Engineering Research Center
Restoration Project, Bldg. 997
Project No. FM120313S/211-77
Addendum No. 2

May 31, 2012

ADDENDUM NO. 2

Reference Detail No. 1

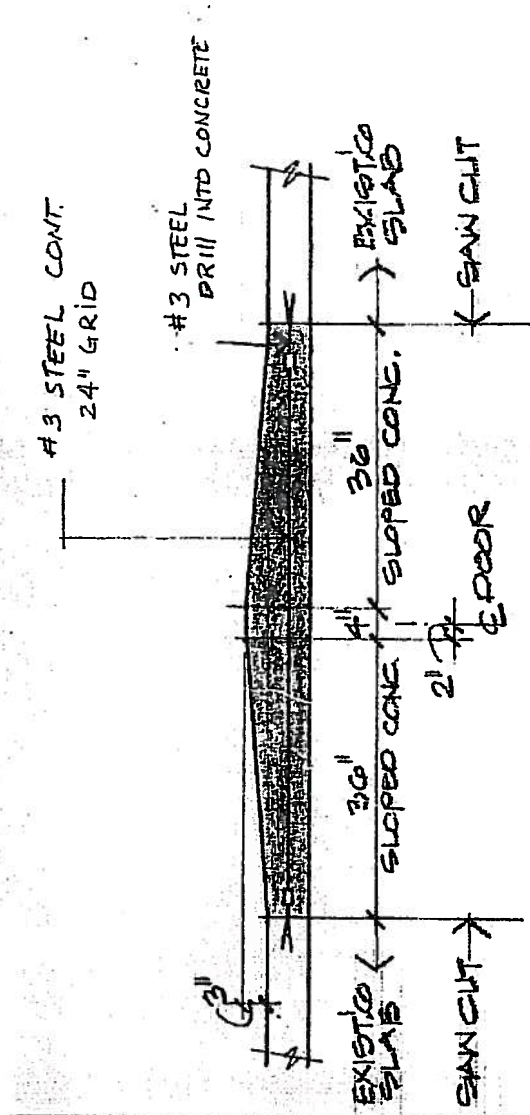
- 1.1** ADD – Paragraph 6: Reference Details No. 1, 2 & 3 taken from the original building construction documents dated 06/14/85. The contractor shall be responsible to field verify all conditions.
